GOVERNMENT OF INDIA
MINISTRY OF ENVIRONMENT, FOREST & CLIMATE CHANGE
Central Zoo Authority

F. No. 19-562/93-CZA(193)(Vol. VI)(NS)/61/2016

Sub:- Revised design of proposed construction of enclosures for White tiger, Wild dog, Wolf and Fox at Nagaland Zoological Park, Rangapahar - Reg.

PLAN & SECTION: FOX ENCLOSURE NAGALAND ZOOLOGICAL PARK, RANGAPAHAR, DIMAPUR

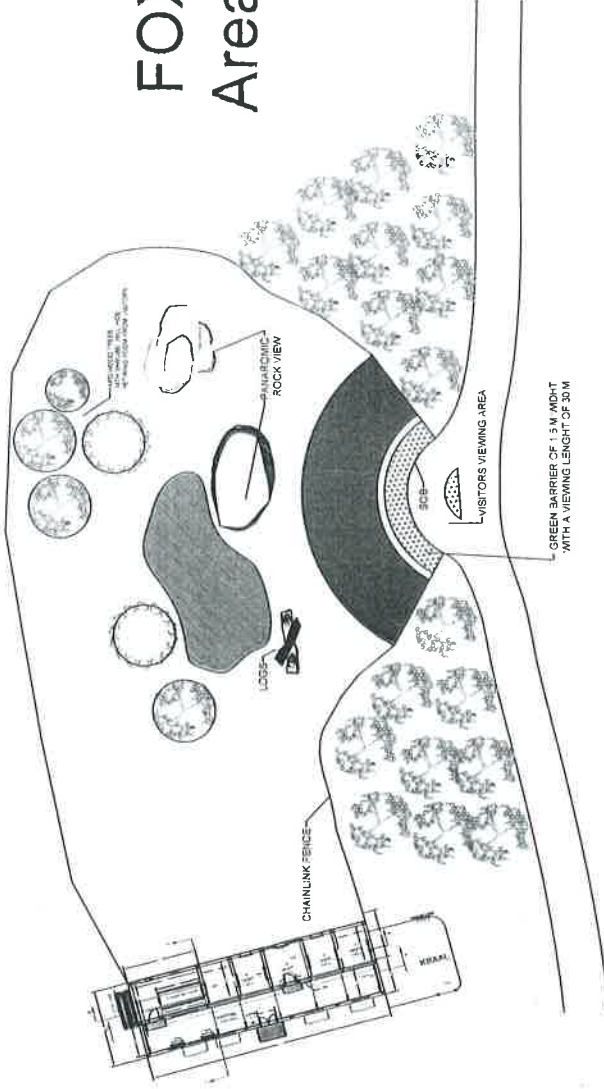
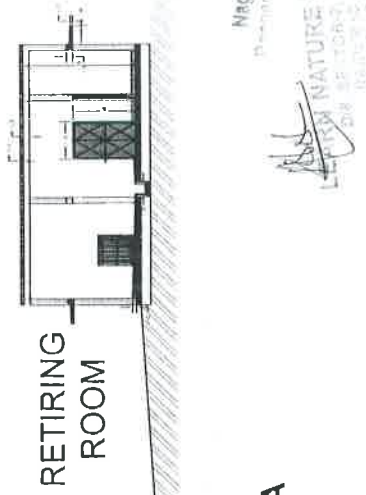
The revised design of enclosure for Fox was scrutinized and approved.
